Applicant: William Zahavi.
U.S.S.N.: 09/965,431
Filing Date: September 27, 2001
EMC Docket No.: EMC-01-160

REMARKS

This amendment is in response to the Office Action mailed October 21, 2005.

FIG. 13

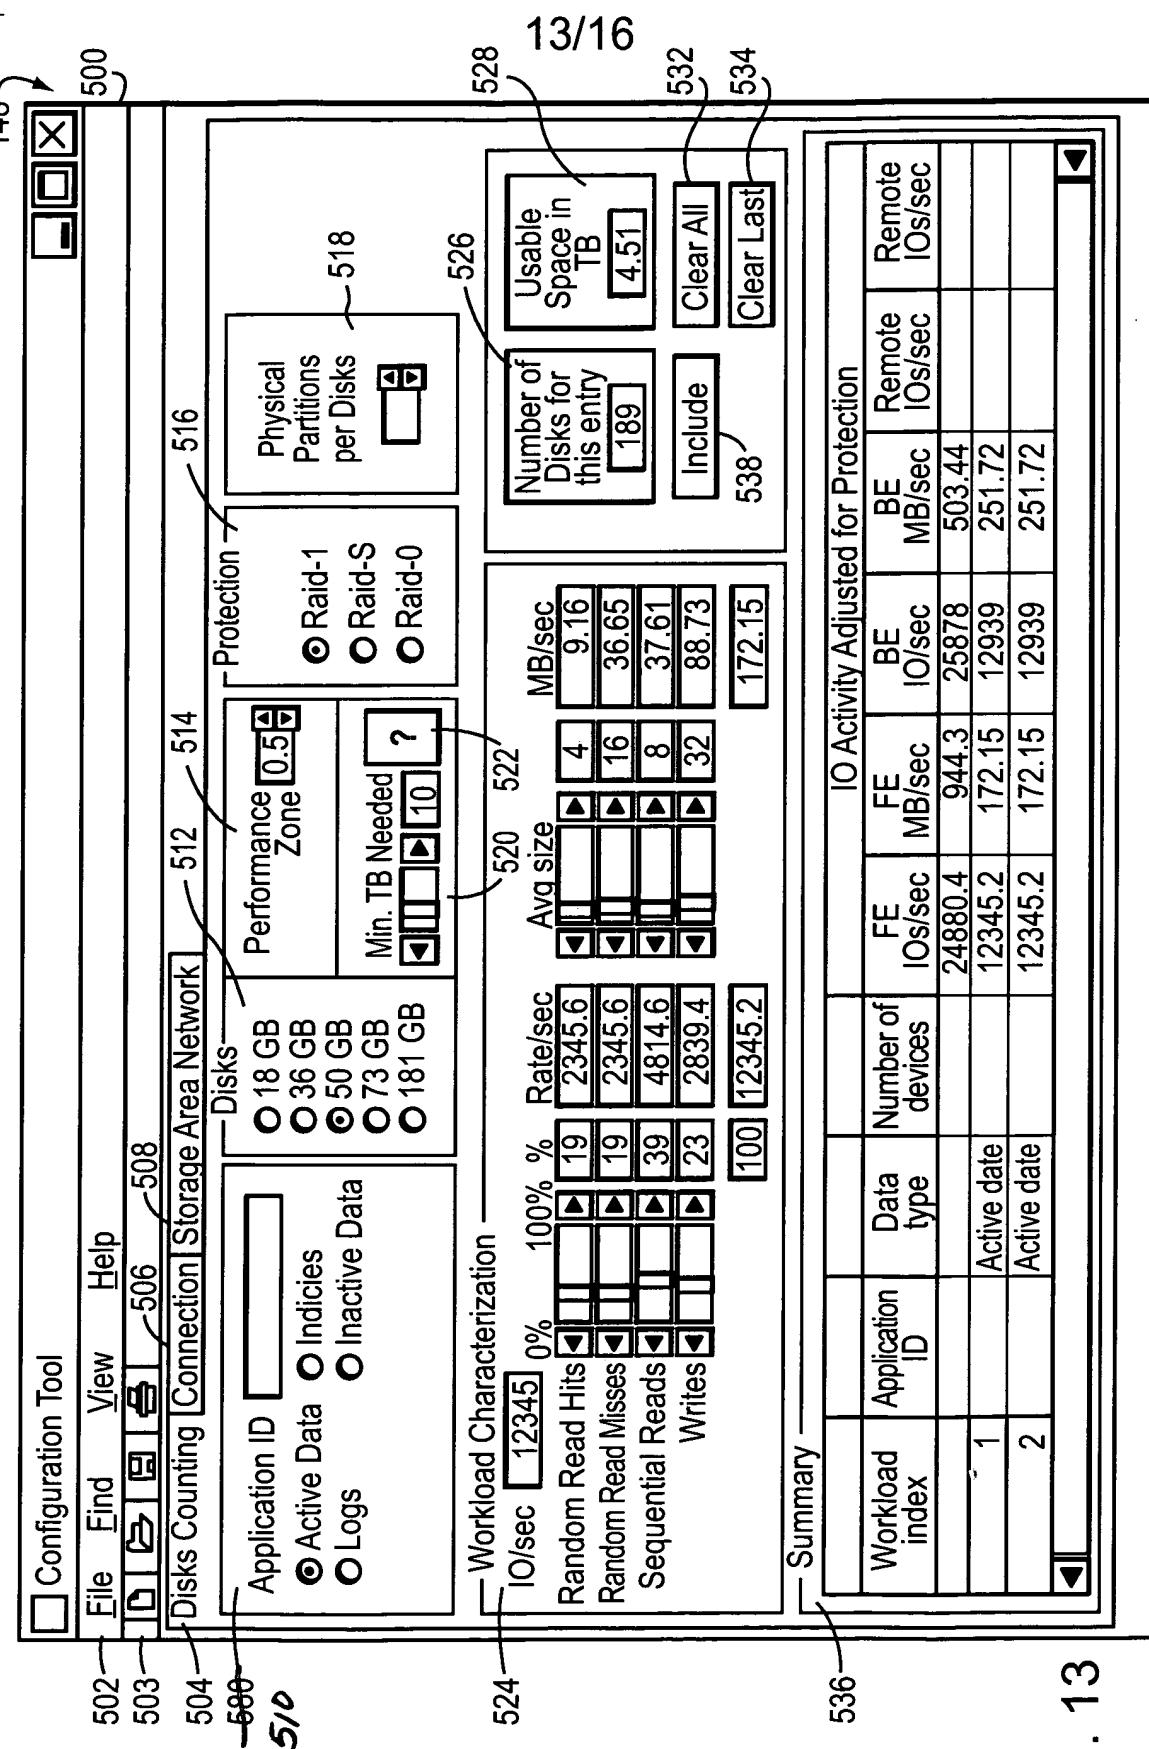
The drawings are objected to because “there is no element ‘510’ in figure 3” (which Applicant believes to be a reference to figure 13), figures 6, 13 and 15 uses the term “RAID-S,” and the reference to RAID-1 is not shown selected.

With regard to the typographical error noted in Figure 13, Applicant thanks the examiner for his observation and has provided a Replacement Sheet properly annotated, in red ink, drawing of Figure 13 to show the amendment made. No new matter has been added. Support for the amendment may be found on at least page 12, lines 14-15, which state “Screen area 510 includes fields for entering Application ID, and fields for indicating ‘Active Data’, ‘Indices,’ ‘Logs,’ and ‘Inactive Data..’”

Figure 13 has been amended to remove the label 580 and replace it with label 510, which is referred to in the written description.
